DOCKET 50-255 - LICENSE DPR-20 - PALISADES PLANT

**PRELIMINARY THERMAL ANNEALING REPORT, SECTION 3, FRACTURE TOUGHNESS
RECOVERY AND REEMBRITTEMENT ASSURANCE PROGRAM - RESPONSE TO
REQUEST FOR ADDITIONAL INFORMATION**

THERMAL ANNEALING REPORT, SECTION 3

Location of weld metal Charpy specimens within test plate

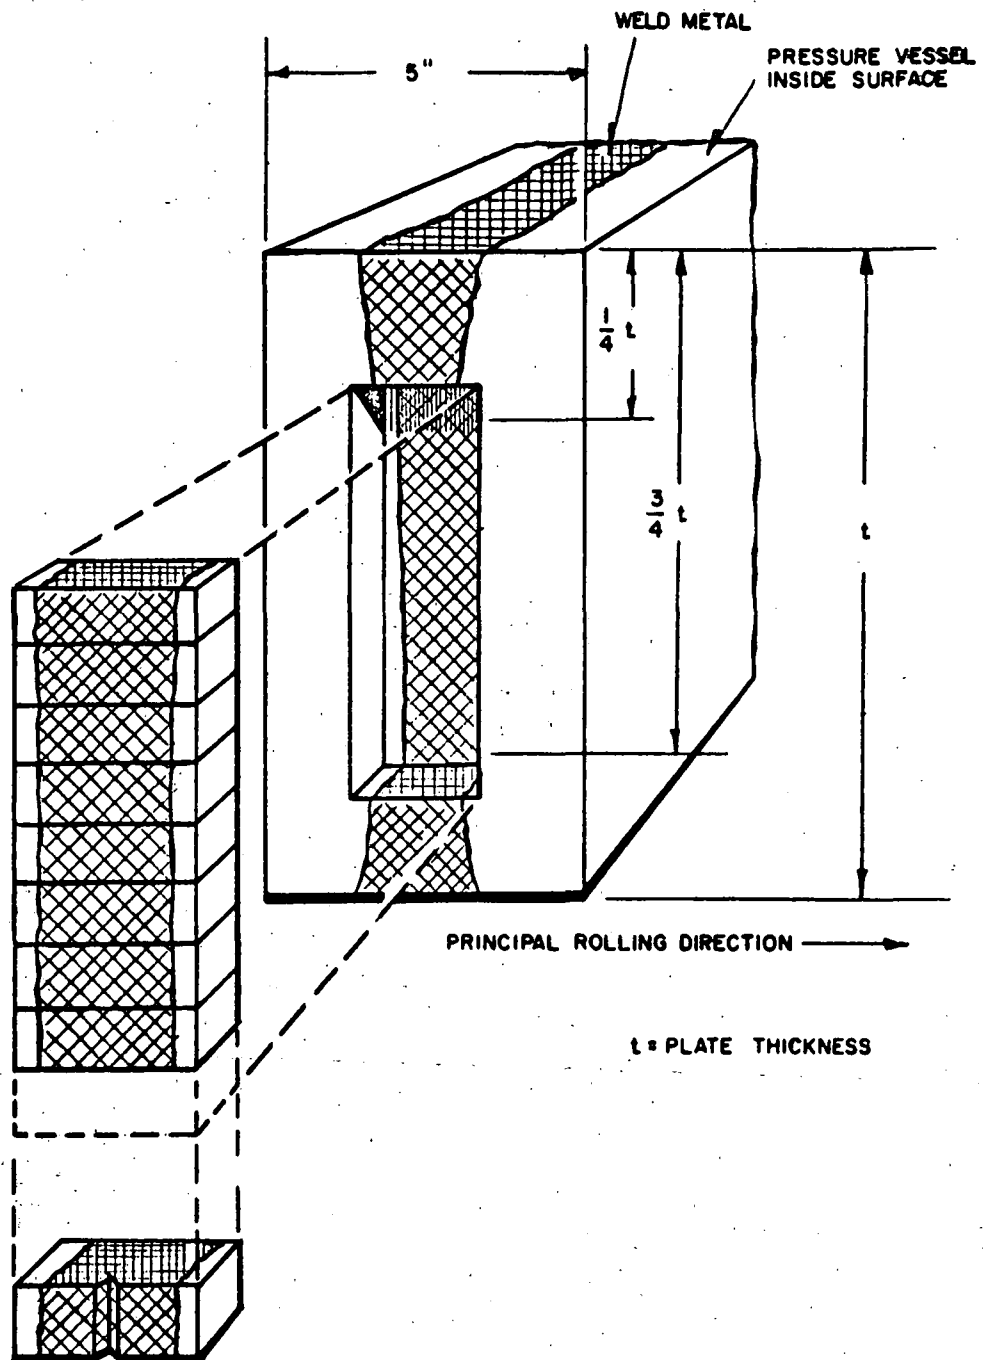
2. *Section 3.1.4.2 states that reconstituted specimens will be tested in the same orientation as the original. What was the original orientation of the specimens in the weld metal? Please provide a drawing showing the orientation.*

The weld specimens were originally oriented parallel to the principal rolling direction of the plate and perpendicular to the direction of the weld. A figure showing the orientation is attached.
